**AVIATION SAFETY ASSESSMENT REPORT
[ADDITIONAL INFORMATION]**

**RE SITE 'R' AT
AERODROME BUSINESS PARK
RATHCOOLE
COUNTY DUBLIN**

**SOUTH DUBLIN COUNTY COUNCIL
PLANNING REG. REF. NO.: SD21A/0140**

OCTOBER 2021

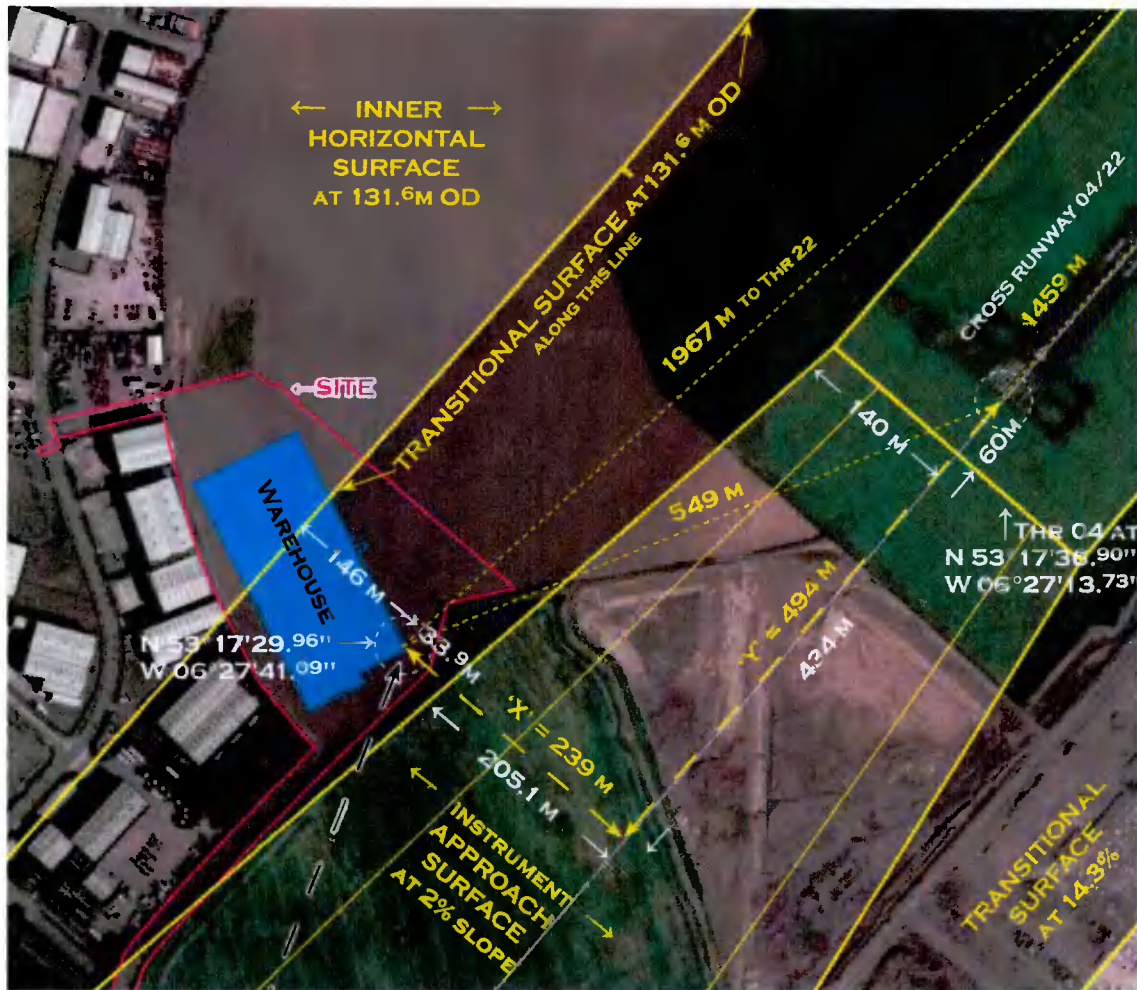
1. The concern with regard to the OLS is the eastern corner of the development. Specifically the Approach Surface for Runway 04 protected as a precision approach runway. Secondly the Transitional Surface may come into play.

- 5.5 **Calculation of Transitional Surface above the site** (as illustrated on the following page):

- (i) At 494m distance (i.e. 'Y') from Threshold 04, the Approach Surface will rise by 2% over 434m [494-60m], i.e. it will rise by 8.68m from 97.2m OD elevation, and will therefore be at **105.88m OD**.

- (ii) This 105.88m obstacle clearance limitation will extend by **140m+65.1m*** to either side of the Approach Surface [** 65.1m = 434×15% widening to each side*].

- (iii) From the edge of the Approach Surface (at 140+65.1m [*i.e. 205.1m*], from runway centreline), the Transitional Surface will rise by 14.3% over the remaining **33.9m**** to the nearest corner of the proposed warehouse, so that the Transitional Surface will lie at exactly 105.88+4.85m OD, i.e. at **110.73m OD above the nearest corner** of the proposed Warehouse. [***239 (i.e. 'X') minus 205.1 = 33.9*]

- (iv) From **110.73m OD** (at its lowest above the Warehouse) the Transitional Surface will continue to rise at 14.3% over a further 146m distance above the Warehouse roof until it reaches the Inner Horizontal Surface at **131.6m OD**.

AT THIS (CRITICAL) POINT
THE TRANSITIONAL SURFACE IS AT 110.73 M OD

5.7 As the highest point of the Warehouse is at **110.05m OD** elevation, and as the sloping Transitional Surface to Casement's Runway 04/22 is at exactly **110.73m OD** at its lowest above the Warehouse, **no part of the Warehouse will extend above the Transitional Surface (or above any Obstacle Limitation Surface).**

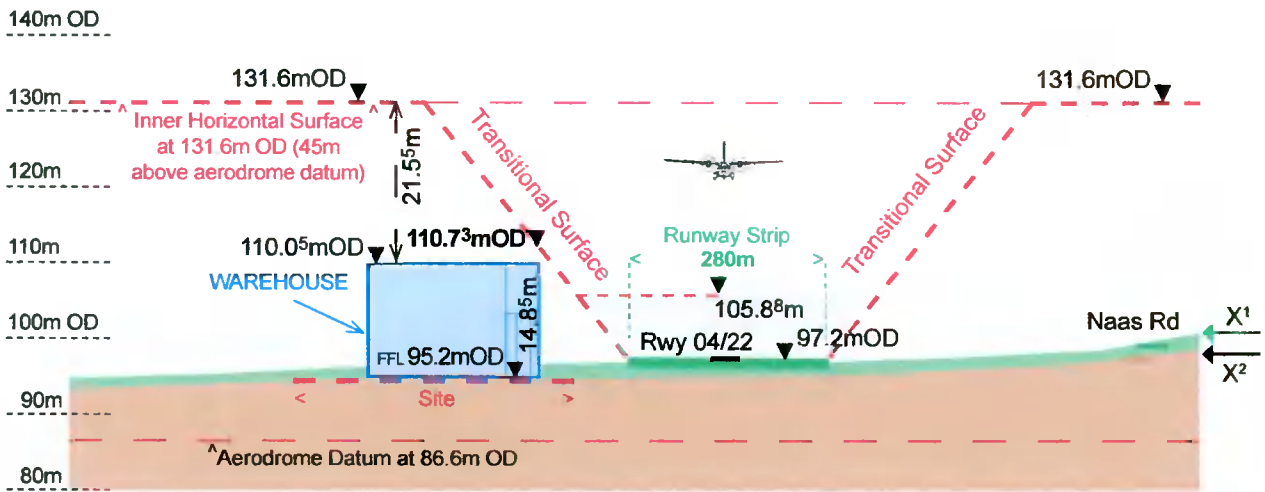
The Department of Defence has expressed concern that the proposed warehouse should not project above any of Casement Aerodrome's 'Obstacle Limitation Surfaces' – in particular the Approach Surface to Runway 04, the Take-off Climb Surface to Runway 22, and the Transitional Surface north-west of Runways 04/22.

6.3 **Approach Surface to Runway 04** (* at 2% 'instrument' slope & 15% divergence): No part of the proposed warehouse is located under this Surface, as it is at 33.9m north-west of the edge of an 'instrument' Approach Surface to Runway 04.

6.4 **Take-off Climb Surface from Runway 22** (at 2% slope): No part of the proposed warehouse is located under this Surface, as it is at 94.7m north-west of the edge of the Code 3 Take-off Climb Surface from Runway 22.

6.5 **Transitional Surface** to north-west of Runways 04/22: Two-thirds of the proposed warehouse lie under this Transitional Surface, with the Surface at **110.73m OD** directly above the eastern corner of the Warehouse (i.e. at **0.68m above** that corner's 110.05m OD parapet elevation). From there the Transitional Surface rises at 14.3% slope to **131.6m OD** elevation (i.e. to **21.55m above** the Warehouse roof) where it joins the aerodrome's Inner Horizontal Surface at 146m horizontal distance to the west.

6.6 **Inner Horizontal Surface** to Casement Aerodrome: One-third of the Warehouse (to its west side) lies under the Inner Horizontal Surface, which is at **131.6m OD**, i.e. at **21.55m above** the Warehouse roof.
